County of Santa Clara

June 28, 2007

Re: Comments to Coyote Valley Specific Plan DEIR

Re: Santa Clara County's Comments to Coyote Valley Specific Plan DEIR

FIGURE 2, USGS QUADRANGLE MAP

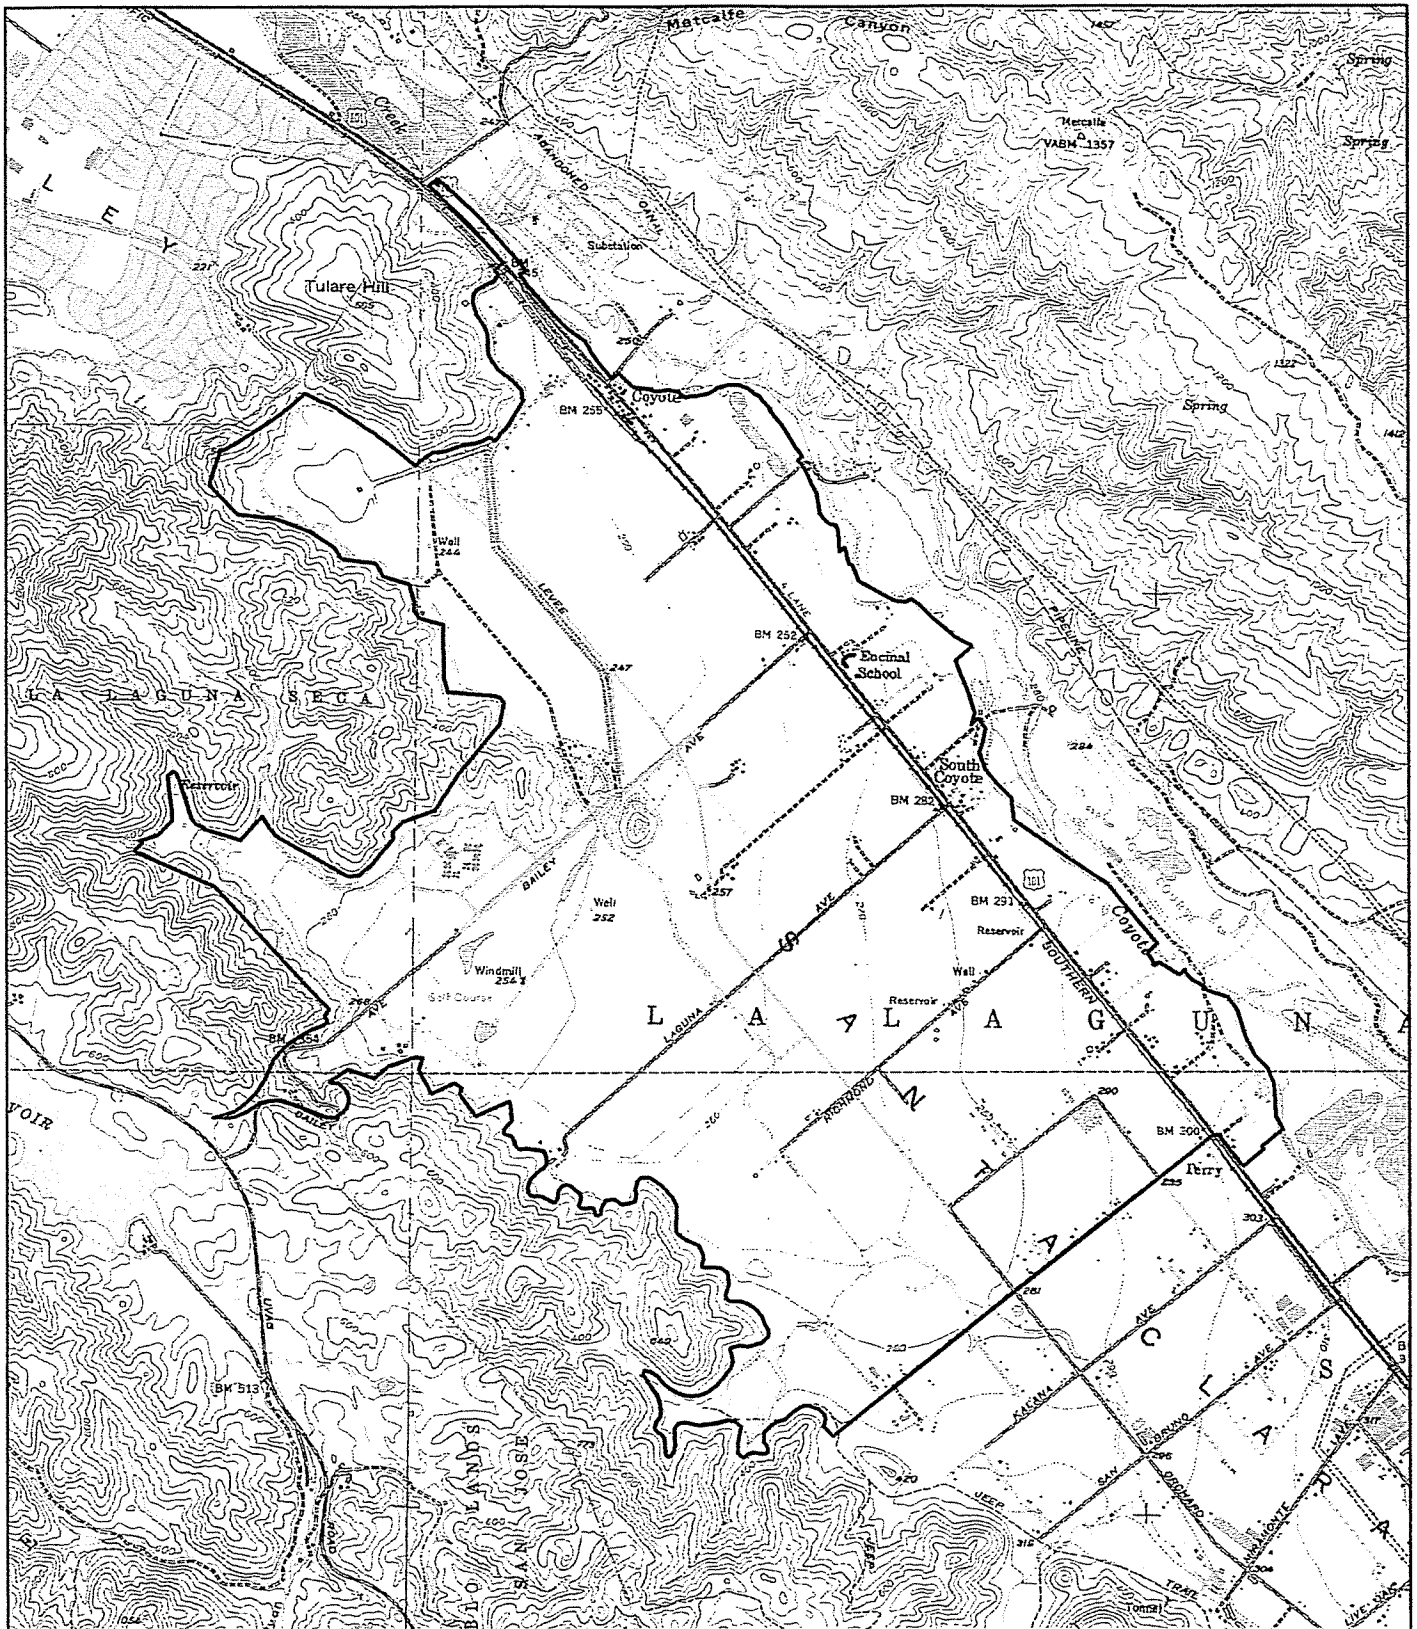
Attachment 2, Figure 2, USGS Quadrangle Map

Figure 1
Extent of Development Proposed within Riparian Habitat Corridor
Santa Clara County Parks Department, CVSP Comment Letter

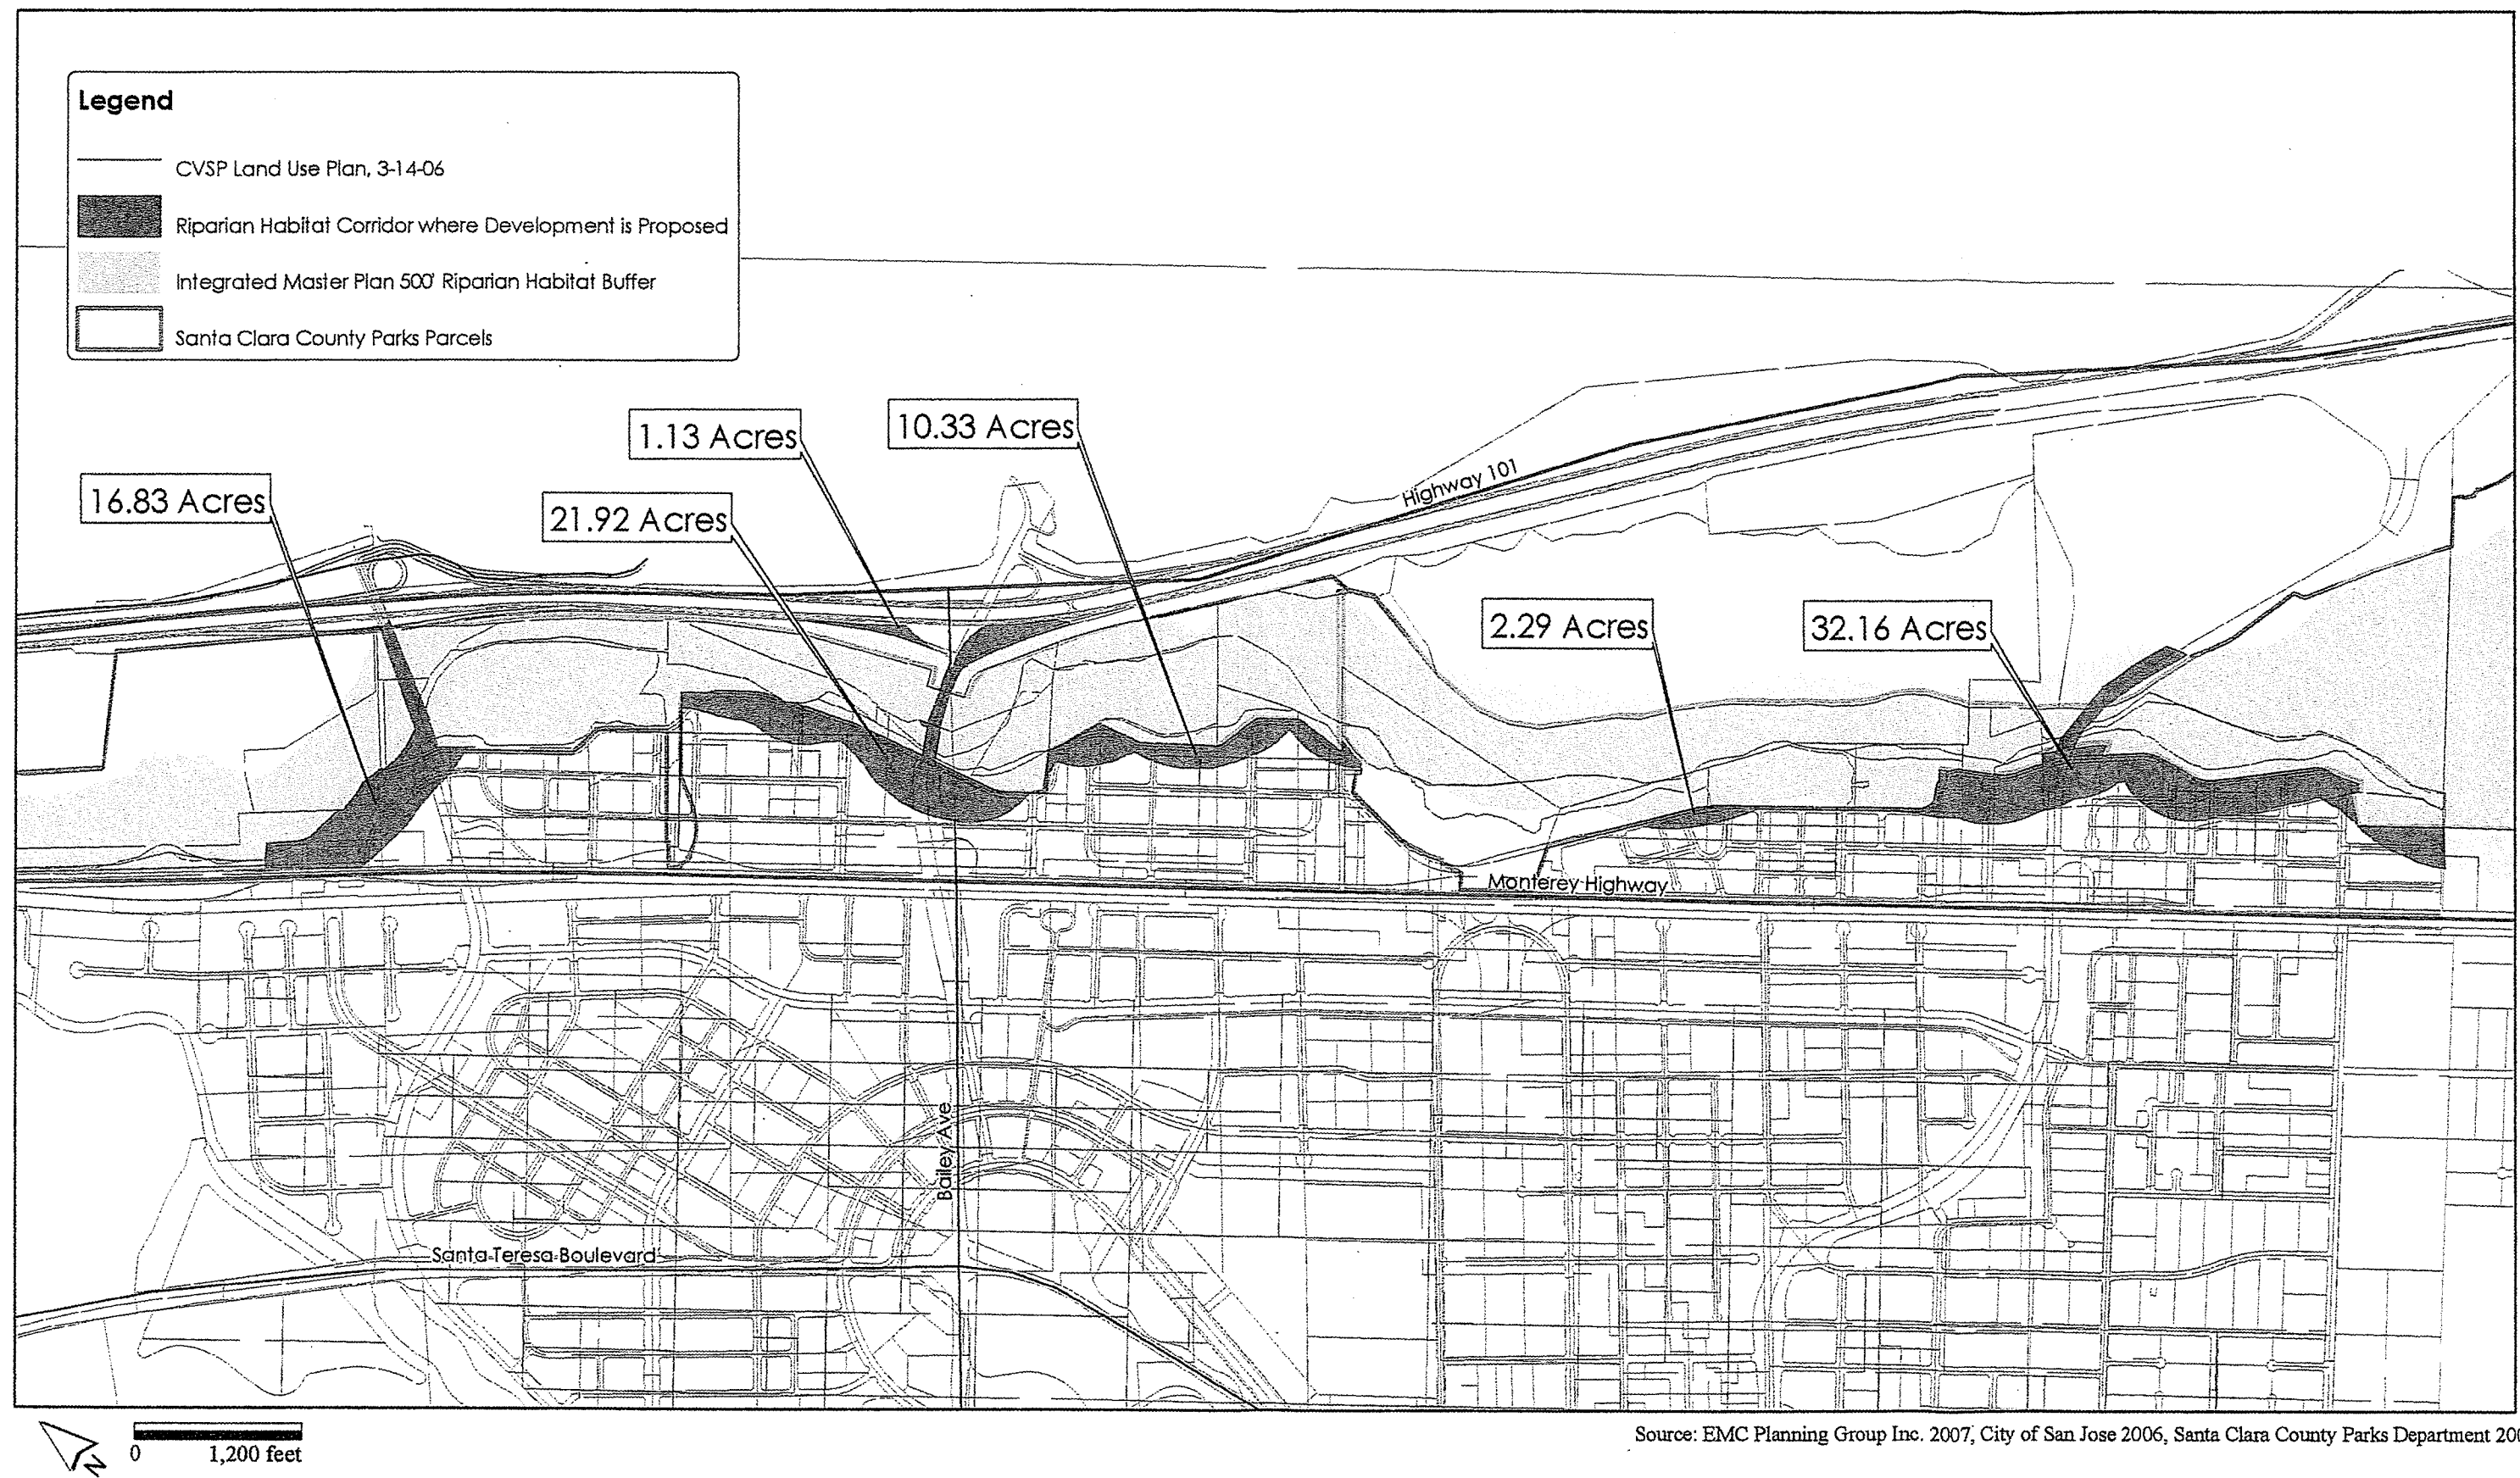
Attachment 1, Figure 1, Extent of Development within Riparian Habitat Corridor

FIGURE 3, IMPACTS TO VEGETATION WHERE DEVELOPMENT IS
PROPOSED WITHIN THE MINIMUM 500-FOOT RIPARIAN HABITAT
CORRIDOR

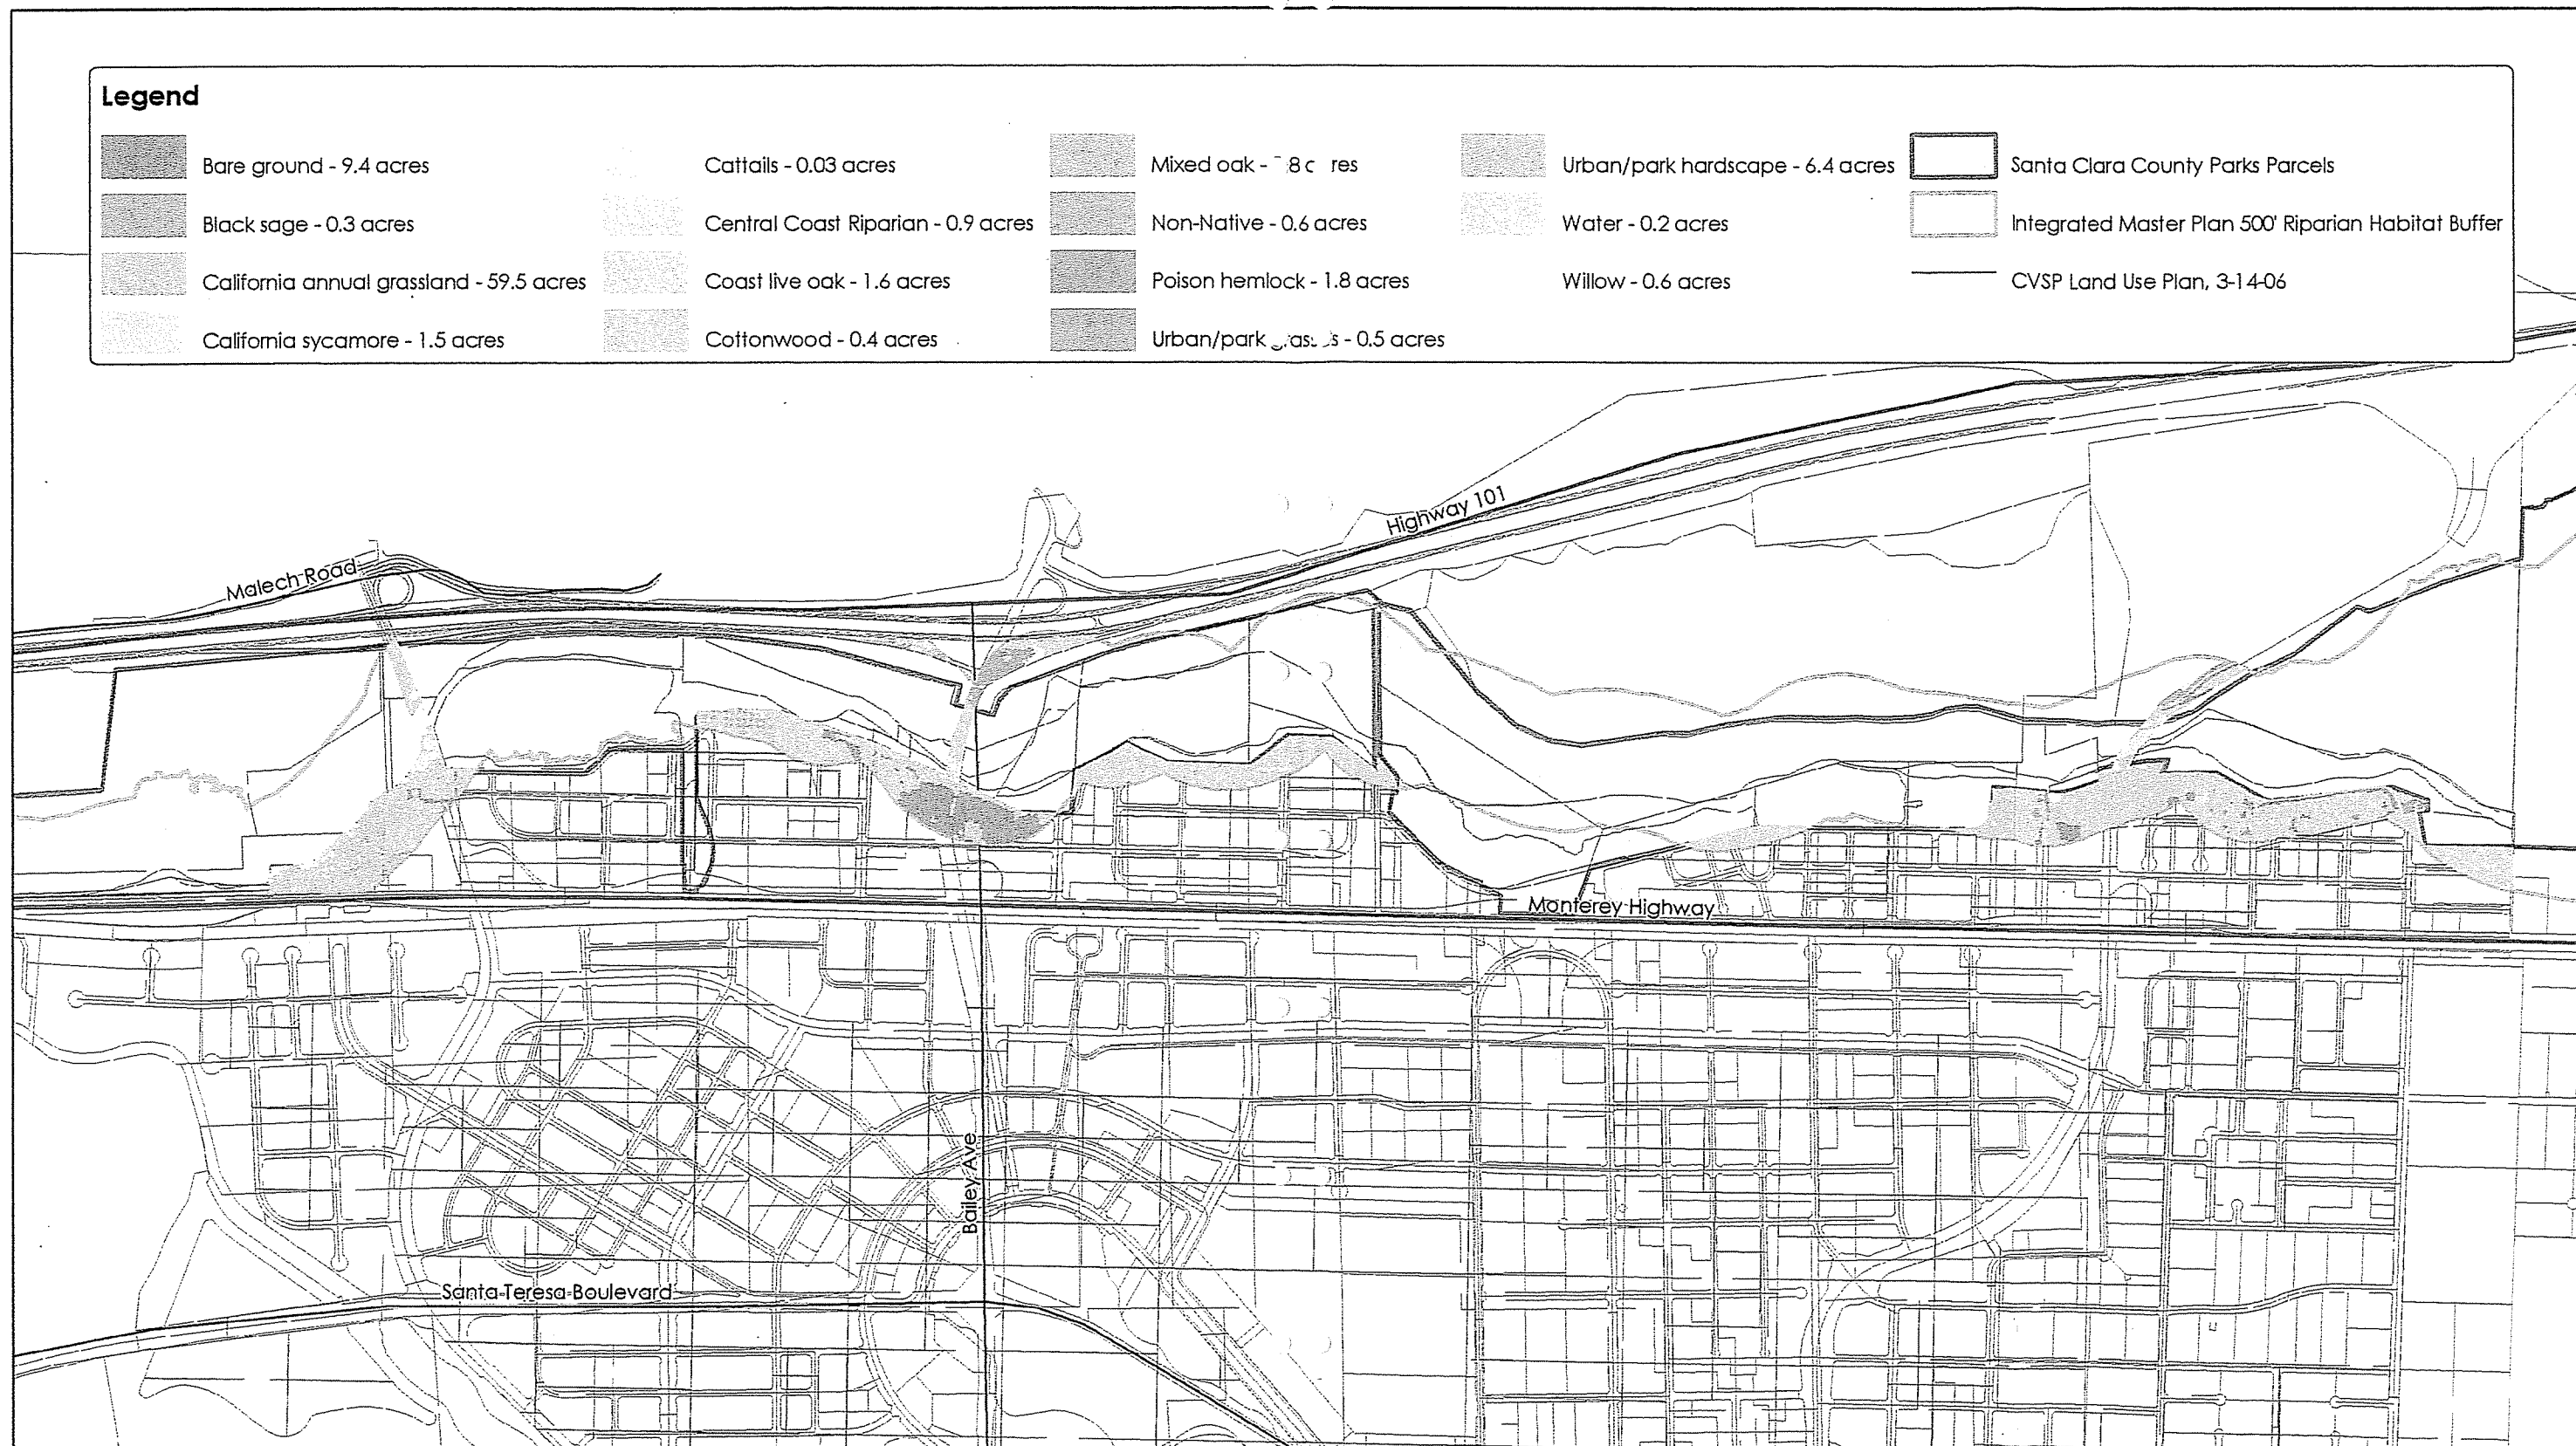
Attachment 4, Figure 3, Impacts to Vegetation where Development is Proposed within the Minimum 500-foot Riparian Habitat Corridor
